Hi-Fi Products
Service Bulletin

Model: CDP-C900

No. 228

Subject: Part Numbers For Bushing And Clip Not Referenced
In Service Manual

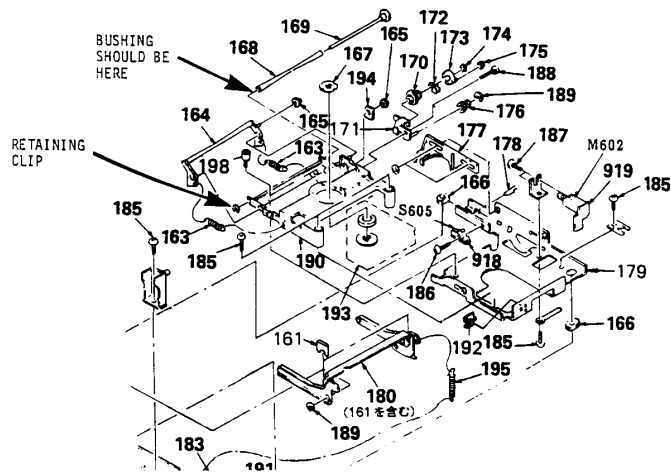
The part numbers for the bushing (not shown at all) and the retaining clip are not referenced in the exploded view of the mechanism on page 27 of the Service Manual.

Solution: The correct part numbers for the bushing and retaining clip are as follows:

DESCRIPTION	PART NUMBER
BUSHING	3-701-438-01
RETAINING CLIP	4-926-218-01
